March 27, 2009

**ADDENDUM NO. 1
TO
THE PLANS AND SPECIFICATIONS
FOR FLEMING PARK PROJECT**

GRADING & DRAINAGE PLAN, SHEET 6 OF 22

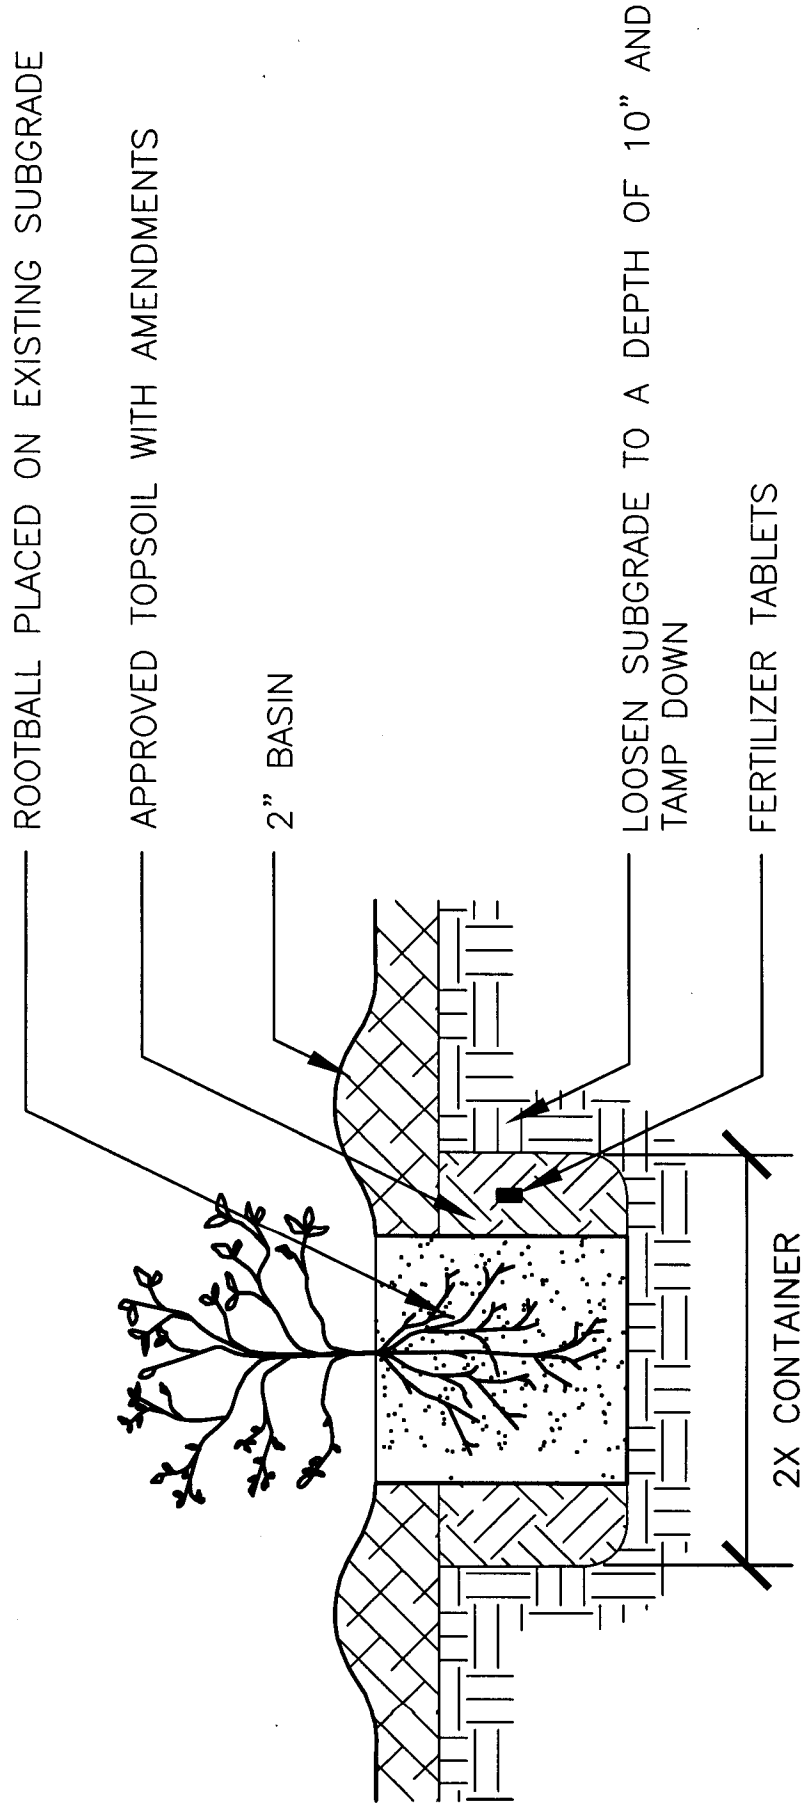
3. **REVISE** symbol on plan from 6" HDPE Plastic Storm Drain Pipe to 12" RCP Storm Drain Line per attached plan.
